February 16, 2016

Anthony Anella, Concerned Citizens Group:

## **RESPONSE** - Analysis of A.R.T. PROJECT PLAN as REVISED 1/22/16

Two-Way Median Busway, Typical Cross-Section

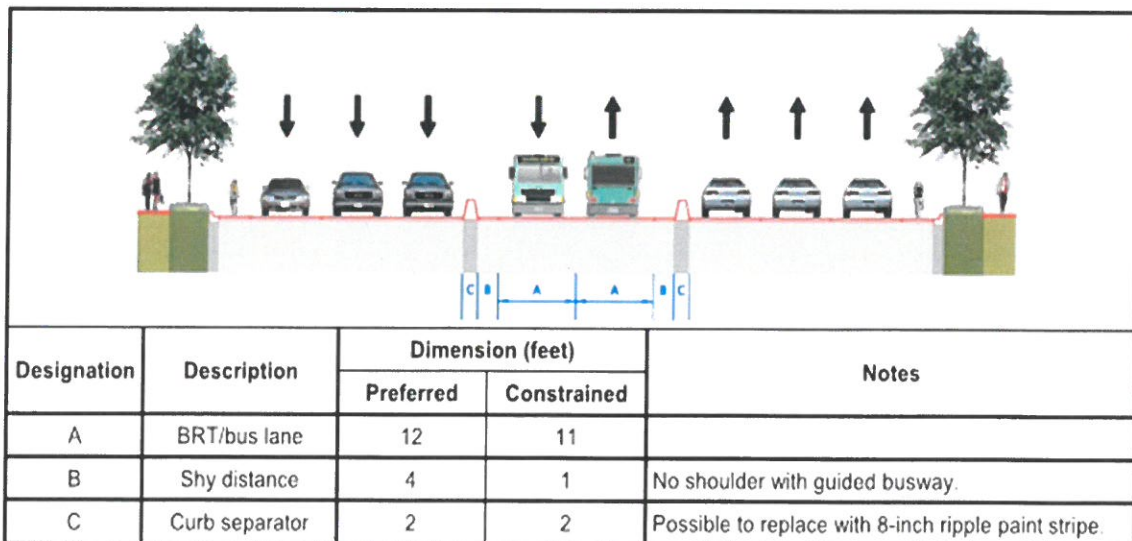
Lanes used by buses: This publication specifies that buses, "...can be 10.5 feet wide from mirror to mirror [true for ABQ RIDE buses] and require a minimum 11-foot-wide lane on roadways with 30 to 35 mph target speeds," (p. 137), exactly the speed of Central Avenue. The publication does not specify a maximum recommended lane width for dedicated bus lanes. ART lanes range from 11 to 13 feet, including an eight-inch rumble strip (essentially a buffer zone) to further delineate the ART lanes from general traffic lanes and discourage use of the lanes by cars. Below is guidance from the American Public Transportation Association (APTA) on BRT lane widths.
